# Appendix 2 : Stakeholder responses to Holmeside Development Framework (23.03.2009 - 19.06.2009)

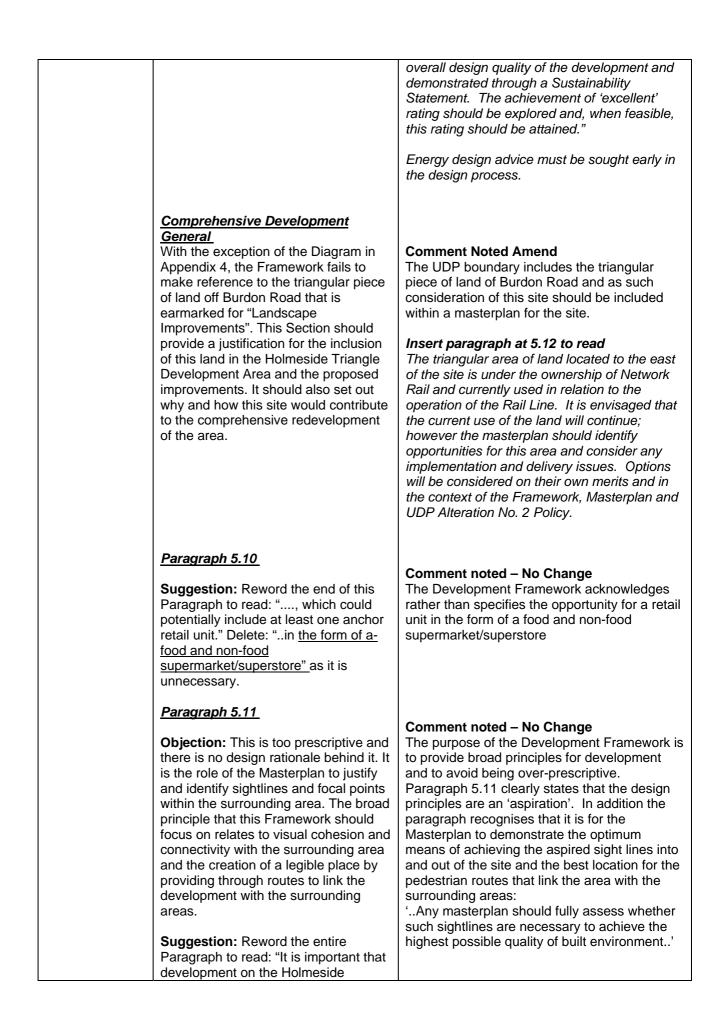
It is also inappropriate for the Diagram to indicate a distribution and zoning of uses on site as this matter is entirely for the Masterplan to establish and justify.	
The identification of the triangular piece of land off Burdon Road for "Landscape Improvements" is gratuitous and not justified by a design rationale. What is proposed (landscape improvements) may not be realistic as a result of ownership constraints and operational considerations. It is also inappropriate for this Framework to suggest that the Holmeside Triangle Development should be burdened with the delivery	
of improvements on this land which is clearly segregated from the main site. The Framework should make it clear

that the delivery of any improvements or development identified by the Masterplan for this site should be assessed on the basis of viability and other implementation issues.	
Suggestion: Delete this Diagram altogether or label it to read: <u>"Indicative Framework Diagram".</u> In addition all key entries (with the exception of "Listed Buildings to be protected/enhanced" and "Mowbray Park: Park and Garden of Special Historic Interest") should be relabelled "potential" or "indicative".	Comment Noted – Amend Amend heading in Appendix 4 to read: 'Indicative Framework Diagram' Amend key entries to read: Potential and indicative where relevant
Reference to the landmark building should be removed or the red circle should be re-labelled as "example of potential landmark location".	Comment noted - Amend
The shading of the site should be in one colour only with the key reading "mixed use retail-led development and public realm."	<b>Comment Noted - Amend</b> <i>Amend shading to identify area of mixed</i> <i>use retail-led development.</i> Public realm will continue to be identified separately and towards the centre of the site where routes converge, in accordance with the vision of the Holmeside Triangle Design Code.

The area identified for "Landscape Improvements" should instead be labelled as "Masterplan to identify opportunities for this area and to assess implementation/delivery issues".	Comment Noted - Amend
